UNITED STATES PATENT AND TRADEMARK OFFICE

10/590,403

Office Action Summary	Application No. 10/590,403	Applicant(s) RHEE, DAE-OK	
	Examiner CANDACE L. BRADFORD	Art Unit 3634

DETAILED ACTION

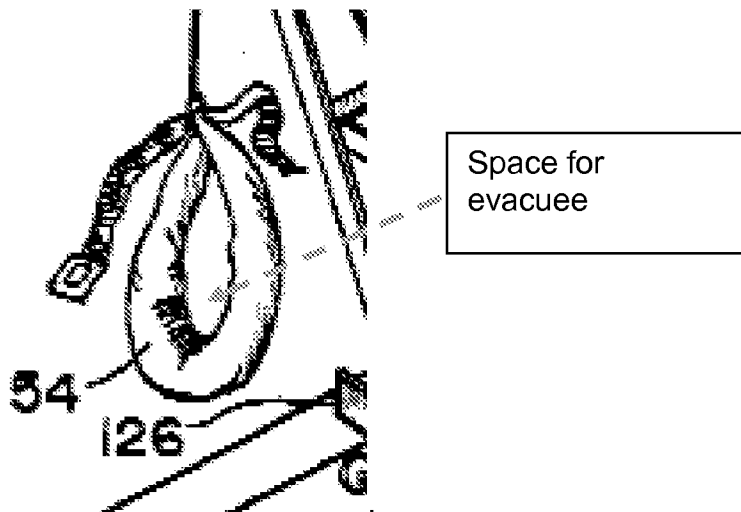
Claim 1 is rejected under 35 U.S.C. 103(a) as being unpatentable over Orgeron (4616735) in view of Varner et. al. (4938435). Orgeron discloses an air tube 54, as recited column 5, lines 28 and 29, ~~Any device capable of carrying the human body can be attached to cable 36 in place of collar 54. For exam-~~ (the examiner has interpreted any device capable of carrying the human body as a air tube) in having an accommodation space, as best seen in Figure 9, for an evacuee and for protecting the evacuee from an external impact, a rope 36, connected to the air tube, having one end fixed to an evacuation place 114, and having a length long enough to reach the ground, but fails to disclose a controller. Varner et. al. teaches the utility of a controller 21, mounted in the air tube and connected to the rope 26, for descending the air tube in which the evacuee is accommodated to the ground at a safe speed, as best seen in Figure 1. The use of a controller is commonly used in the art to allow the evacuee to have manual control when evacuating from building or tree to the ground. Therefore, it would have been obvious to provide the evacuation device of Orgeron with a controller as taught by Varner so as to allow the evacuee to have manual control when evacuating from building or tree to the ground..

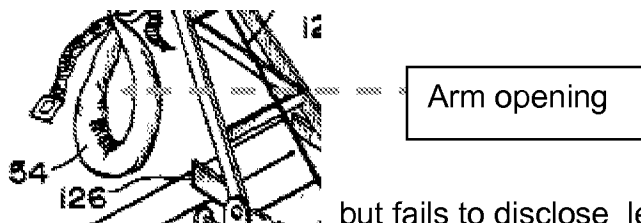
Claim 4 is rejected under 35 U.S.C. 103(a) as being unpatentable over Orgeron (4616735) in view of Varner et. al. (4938435) in view of Woodland (5597335). Orgeron in view of Varner et. al. as advanced about fails to disclose the air tube being made of a fireproof material. Woodland teaches the utility of an evacuation device having an airtube being made out of a fireproof material. Fire proof materials being used in

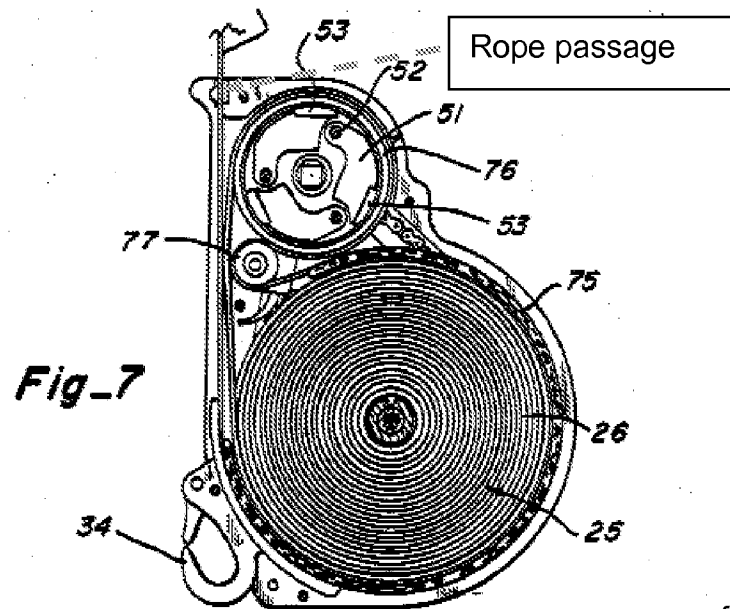
but fails to disclose leg openings and a zipper. Elsholz teaches the utility of a pair of leg openings 26, for allowing the evacuee's legs to extend outward are respectively formed at a front surface of the air tube, and a zipper 74 is

respectively provided at the arm openings and the leg openings 26. The utility of leg and arm openings are commonly used in emergency device to allow an evacuee to secure limbs in the device. Therefore, it would have been obvious to one of ordinary skill in the art to provide the evacuation device of Orgeron in view of Varner et. al. with opening for legs to extend through as taught by Elsholz so as to allow an evacuee to secure limbs in the device.

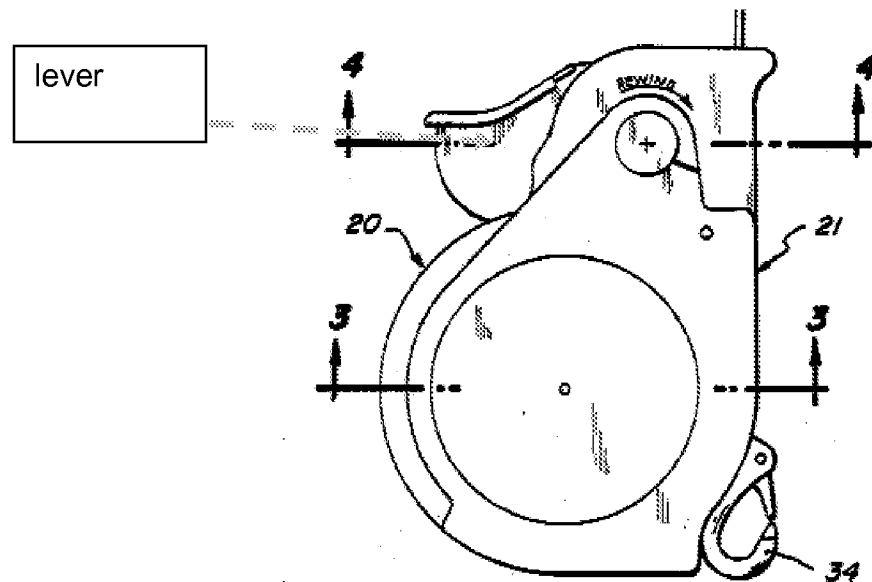
Claim 9 is rejected under 35 U.S.C. 103(a) as being unpatentable over Orgeron (4616735) in view of Varner et. al. (4938435). Varner further discloses the apparatus of

claim 8, wherein a rope passage

passing the rope is respectively formed at upper and lower ends of the controller as

best seen in Figure 7, and a lever

adjusted by the evacuee inside is mounted at a front side of the controller.
